VSH PREMIER CIRCLE ARB 2022-29

SUBMISSION OF FINAL SITE PLAN

May 8, 2023

VSH PREMIER CIRCLE - ARB 2022-29

item 8: ELEVATOR TOWER VISIBILITY AND MATERIAL

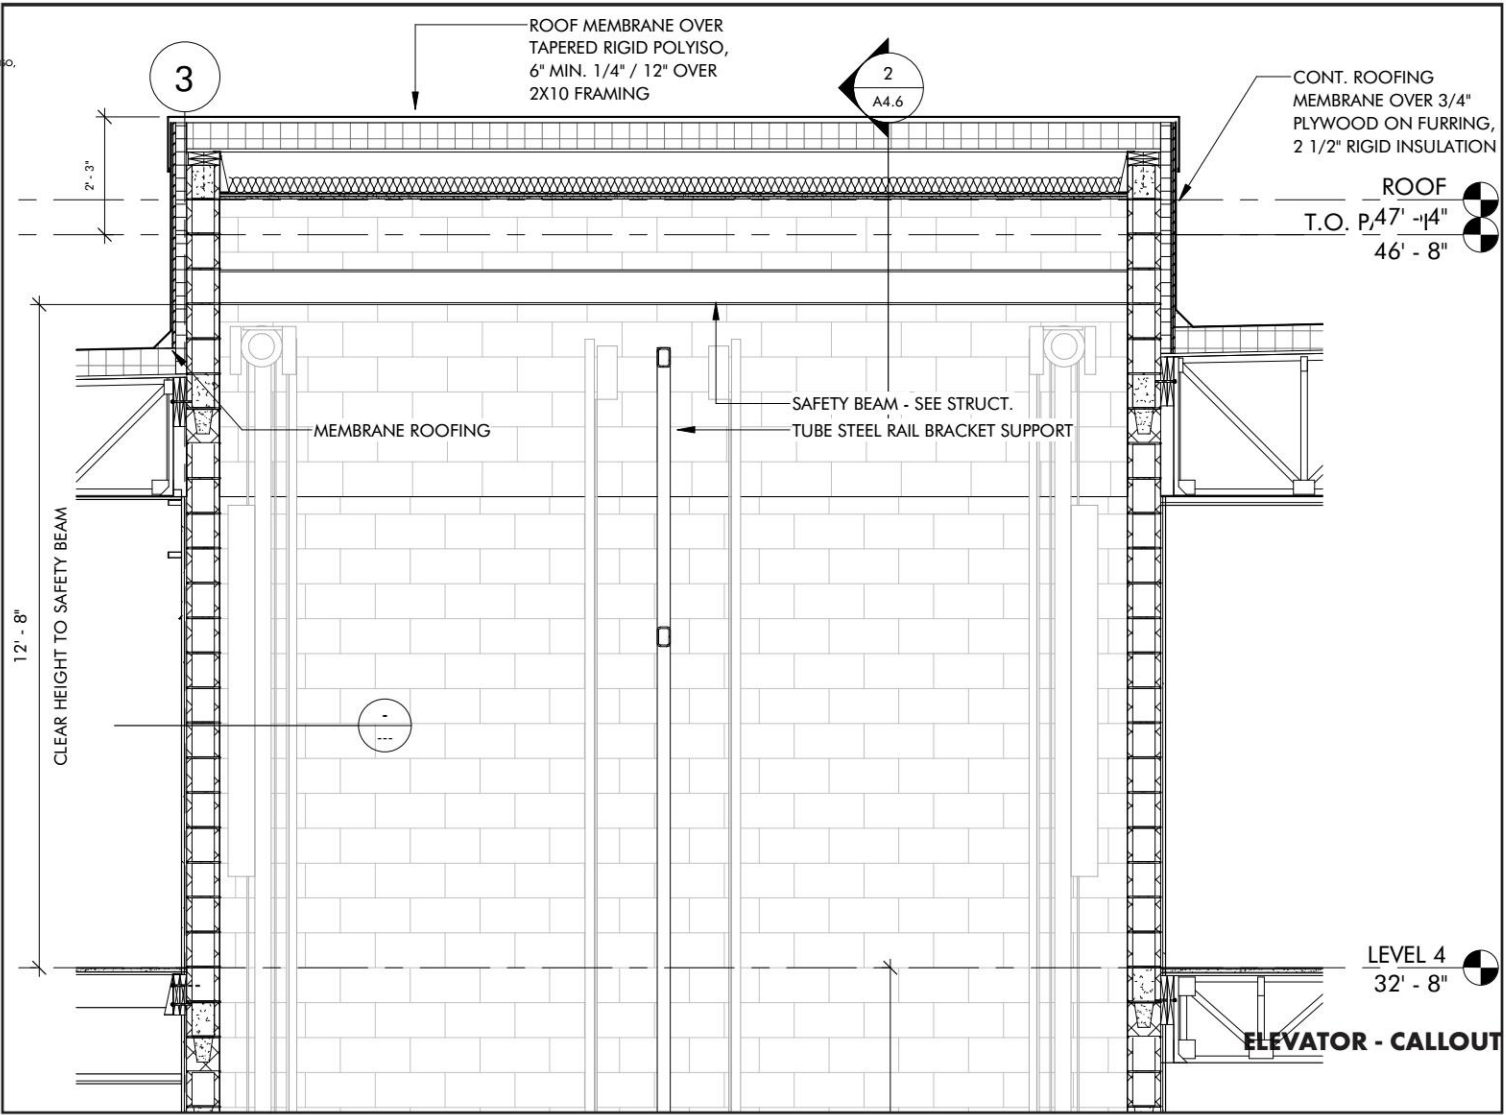
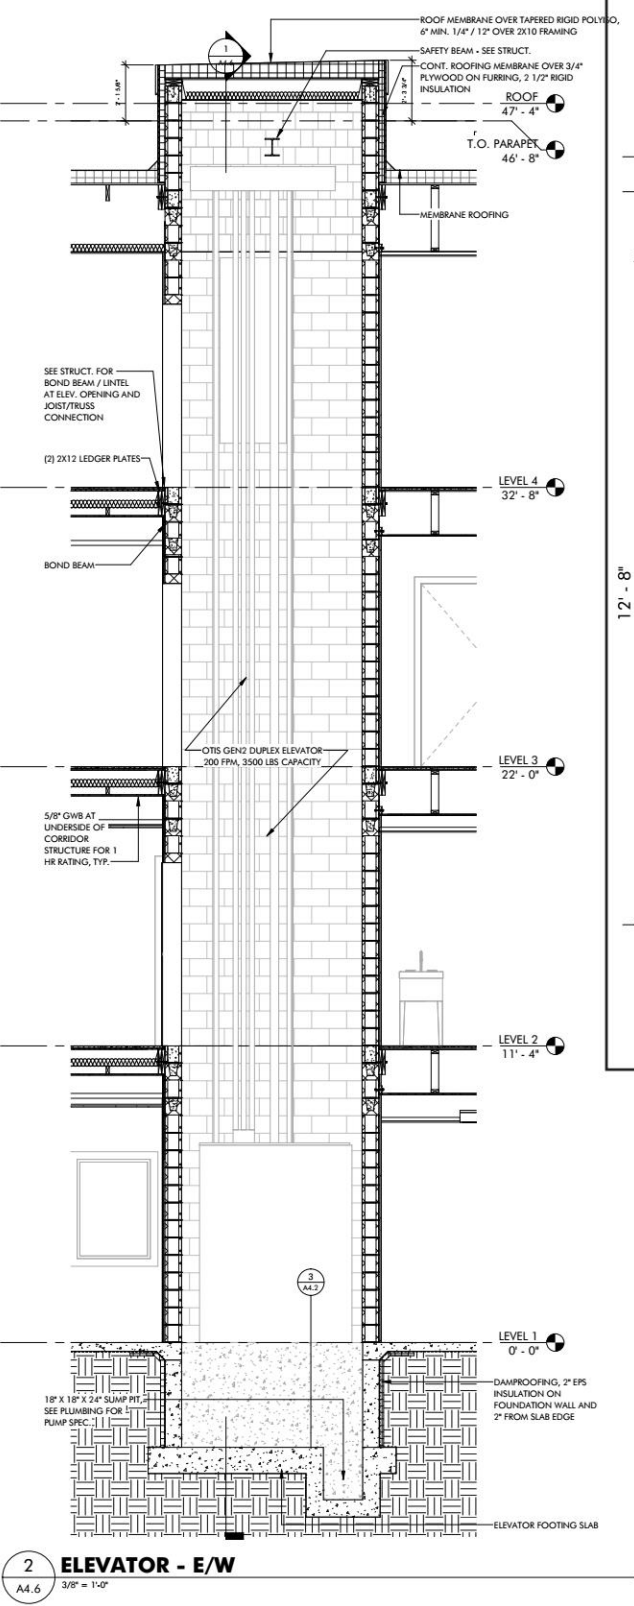
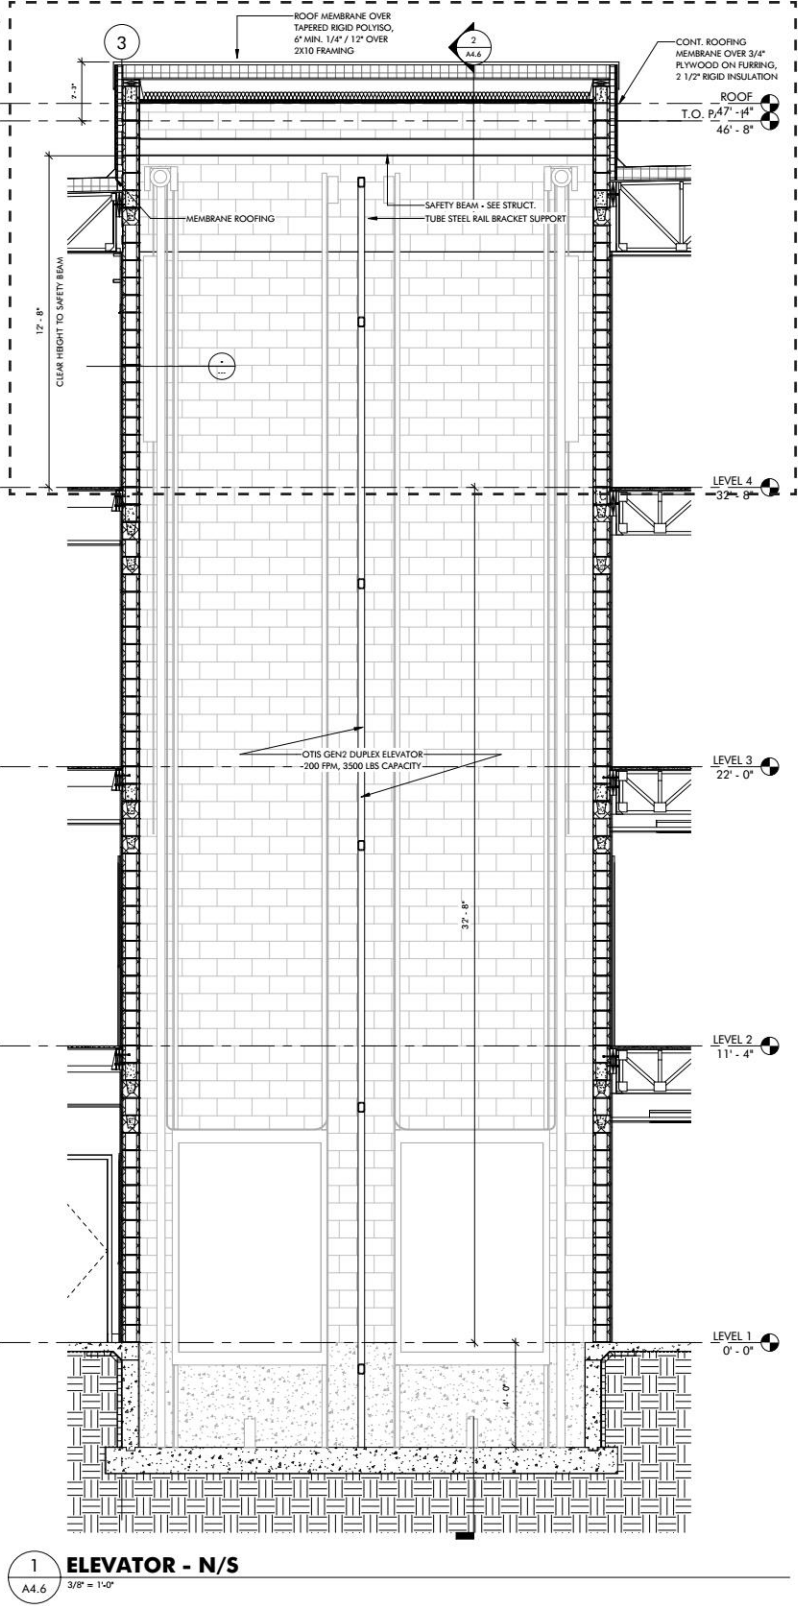
8. Revise the architectural drawings to show the finish (material, color, detailing) of the elevator tower and show the tower in the perspective drawings.

9. Add the standard mechanical equipment note to the architectural plans: “Visibility of all mechanical equipment from the Entrance Corridor shall be eliminated.”

In the renders to the right, the mechanical equipment and elevator tower do not appear until the view is taken from 21’ above the ground and higher, therefore we can confirm the visibility has been considered from typical perspectives on the entrance corridor. See page 13 for more details regarding the roof plan.

See note below. See page 13 for more details regarding the roof plan.

ELEVATIONS - EAST (FROM PREMIER CIRCLE) - PARTLY VISIBLE FROM E.C.
Scale: 1/16" = 1'-0"

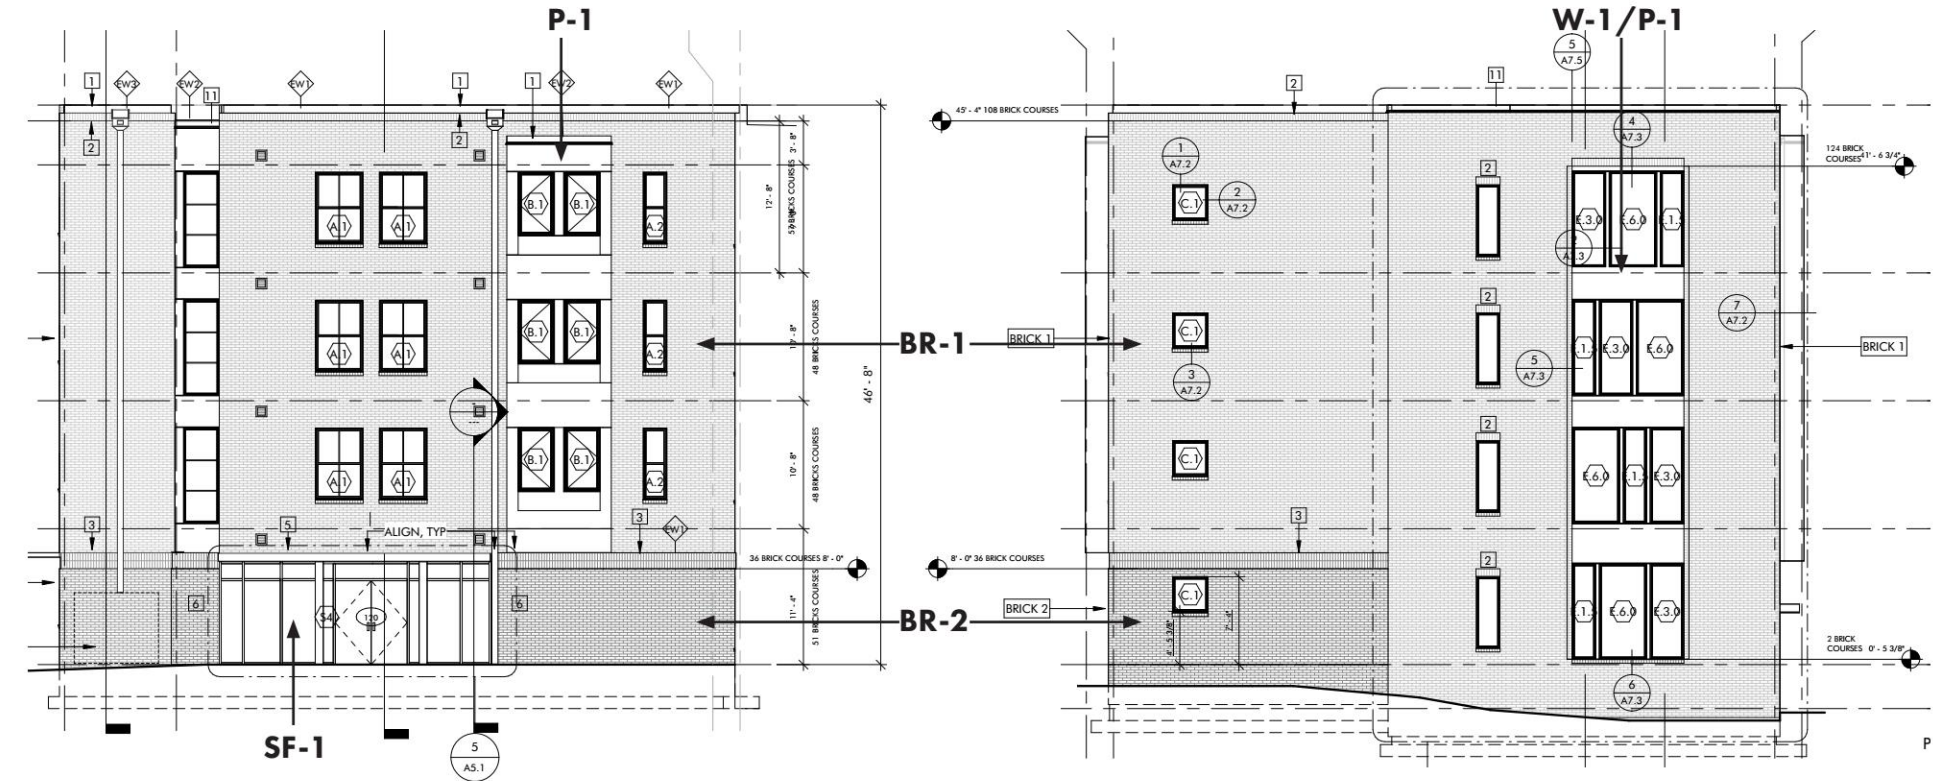
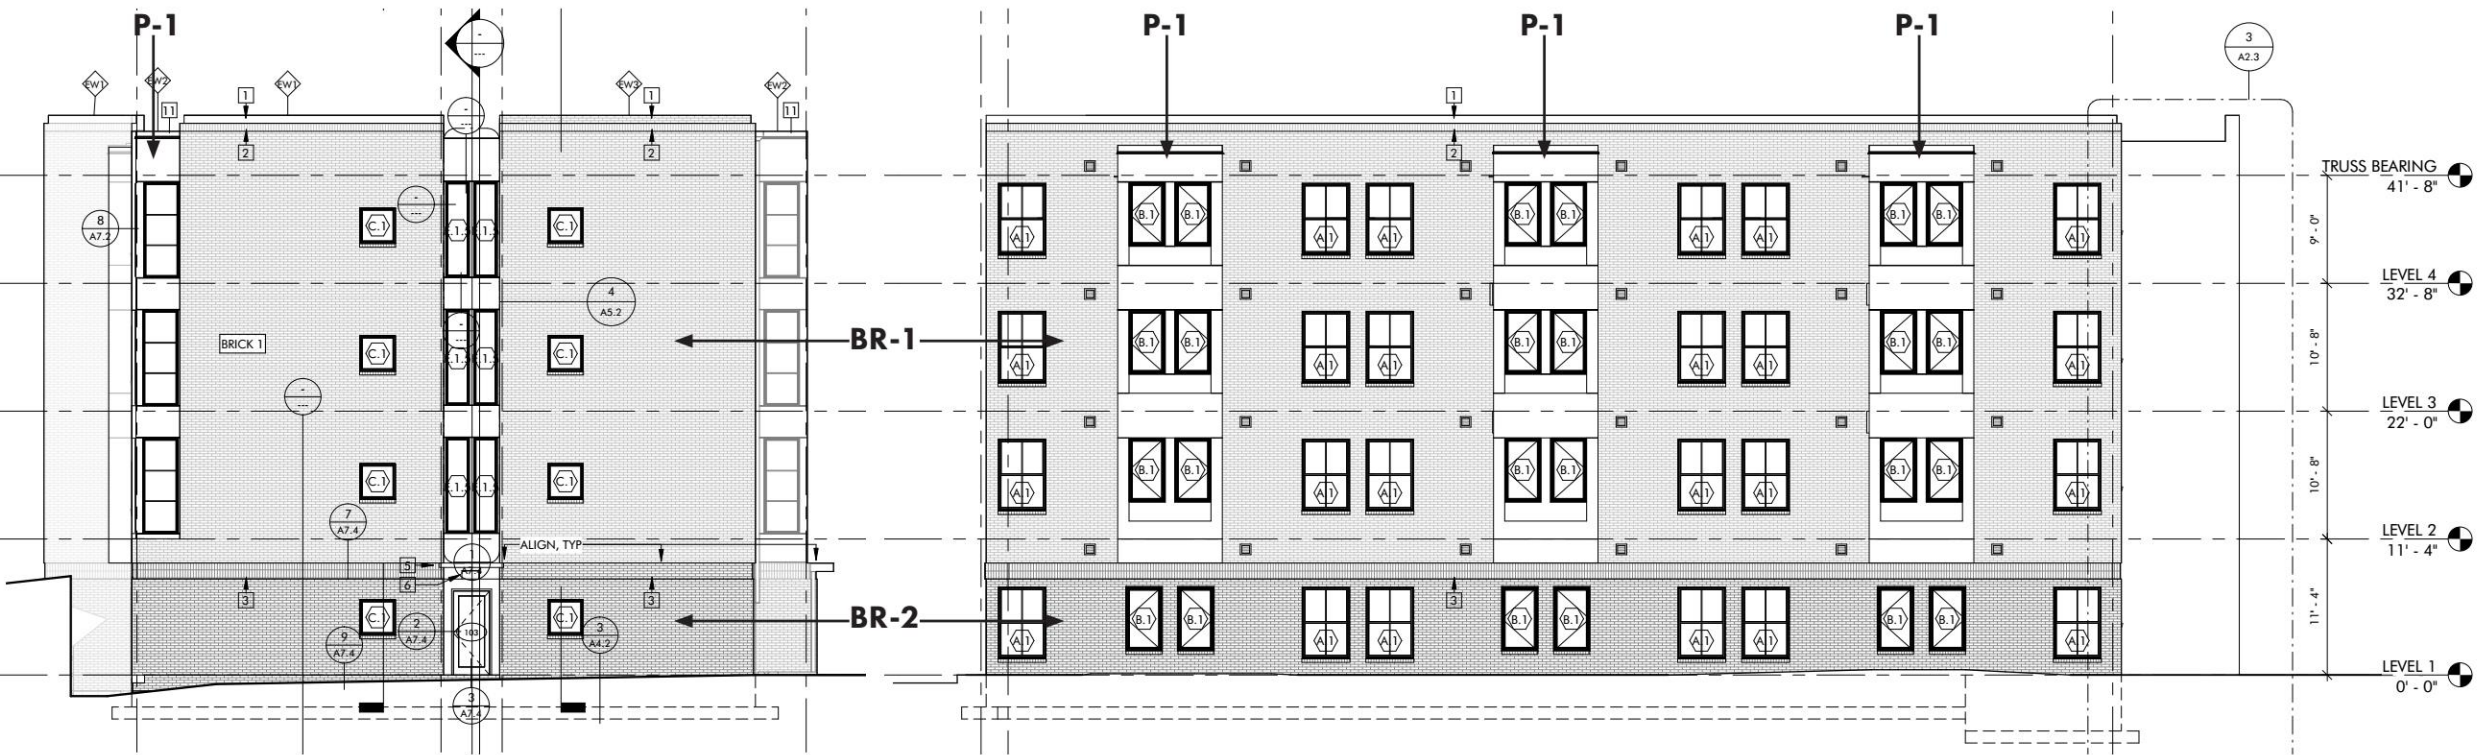
Revise the architectural drawings to note conformity with the updated window glass specifications. The updated specifications are visible light transmittance (VLT) shall not drop below 40%. Visible light reflectance (VLR) shall not exceed 30%.

Add the standard mechanical equipment note to the architectural plans: "Visibility of all mechanical equipment from the Entrance Corridor shall be eliminated."

See note below.
